Mildmay Liveable Neighbourhood summary of co-design engagement (Feb-April 2023)

About the Mildmay Liveable Neighbourhood project

Proposal 3 – Traffic filtering options

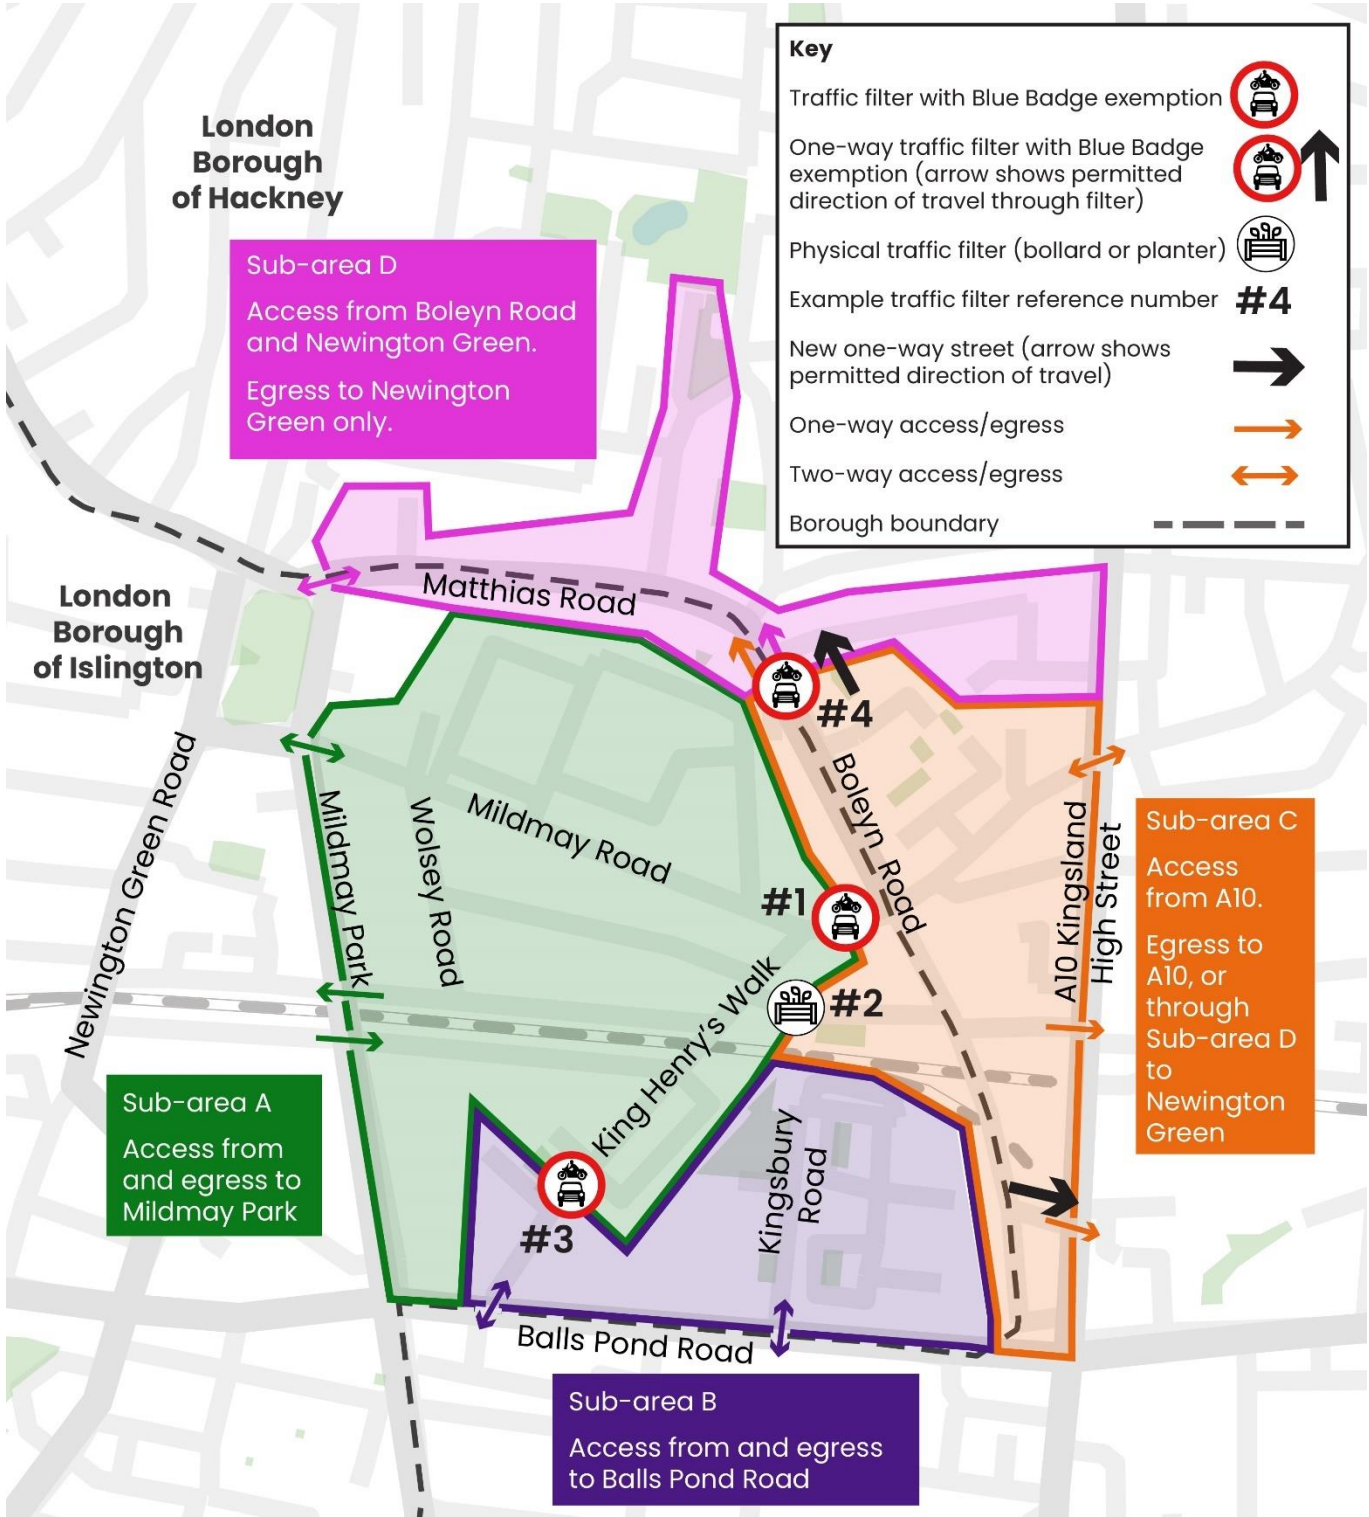
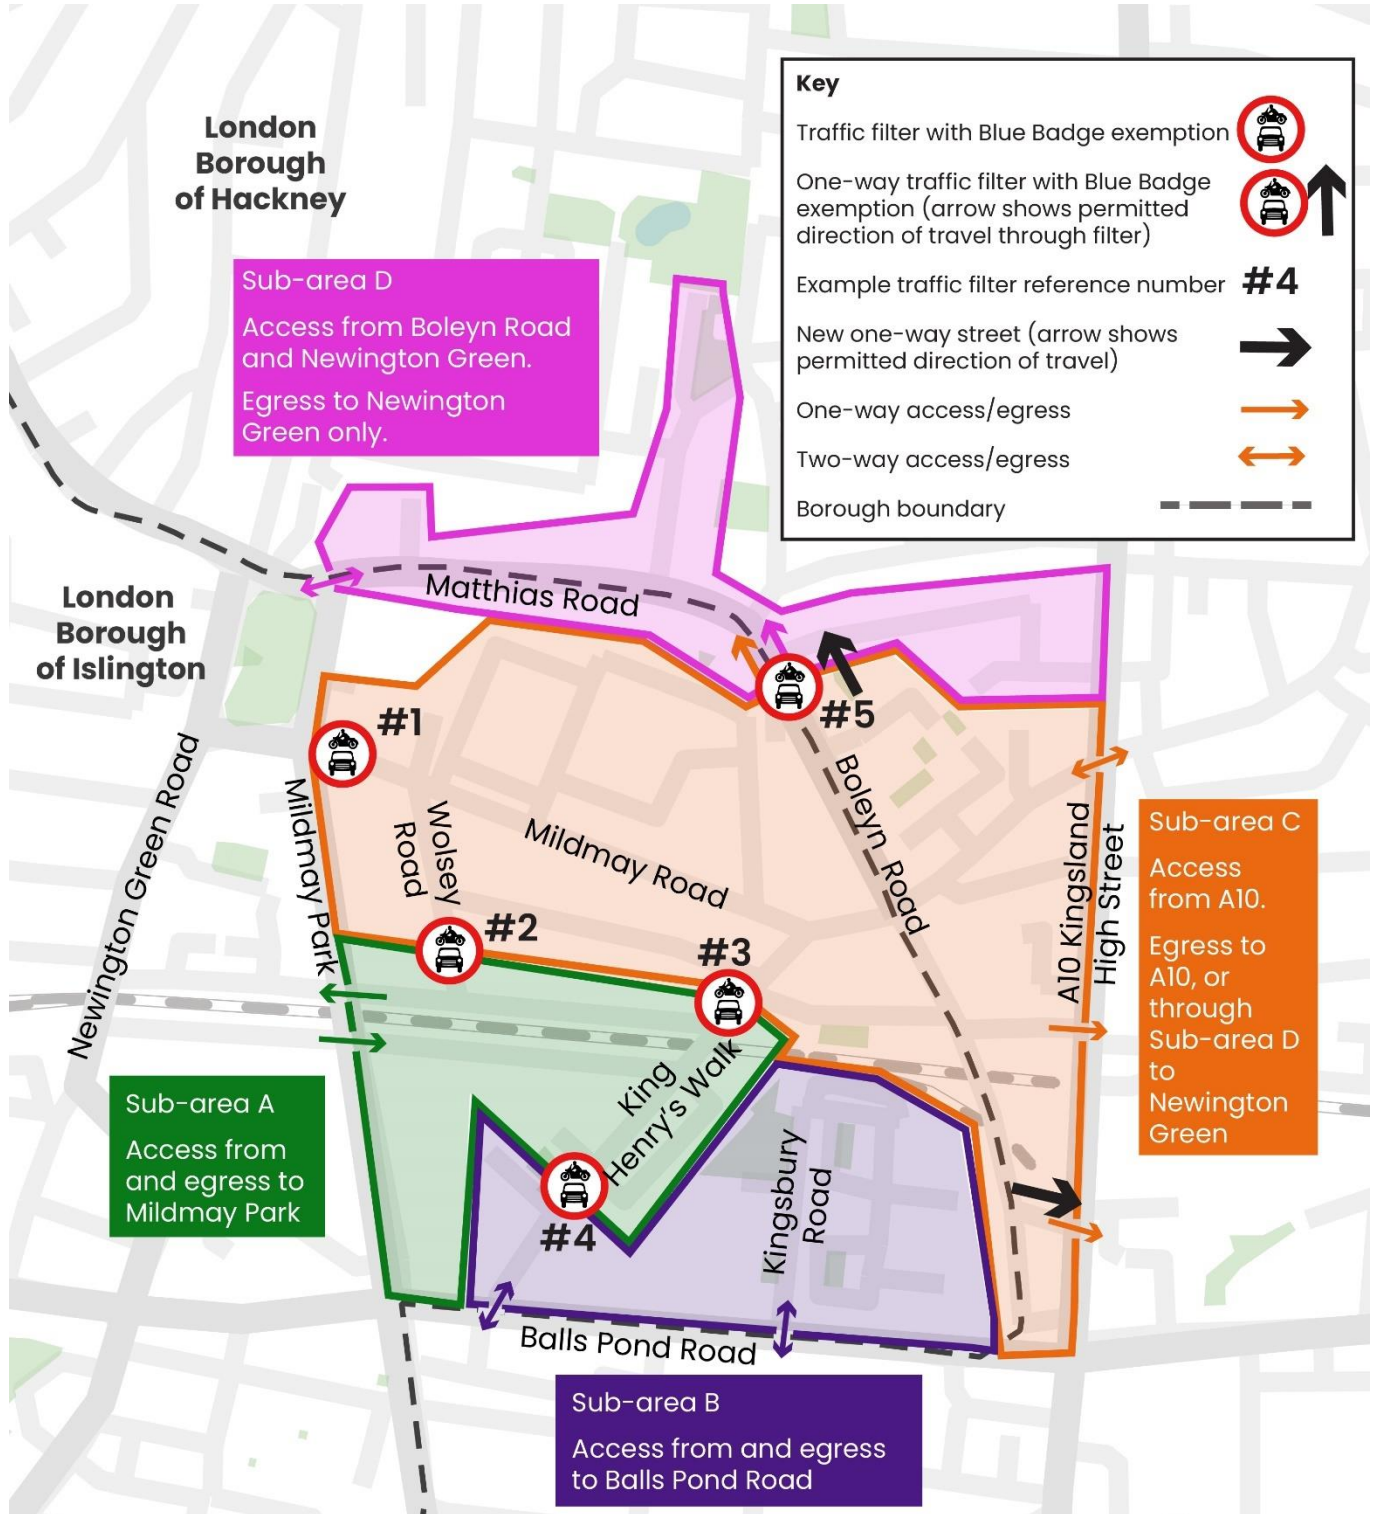
The most common theme in responses showed that there was general support for the proposals. Also among the most prevalent themes: some responses expressed support in their own words (unprompted) for the introduction of traffic filtering because it would reduce air pollution, and it would help to reduce traffic; and some responses also explicitly expressed support for traffic filtering option 1 over traffic filtering option 2.

The most common negatively-themed comments included concerns about traffic displacement as a result of filtering, concern that air pollution will not be reduced due to traffic displacement, concern about residents accessing the scheme area by motor vehicle, and that the scheme was unnecessary/waste of money. The vast majority of more negative-leaning themes coded from the comments were made by respondents who said they owned or had access to a car.
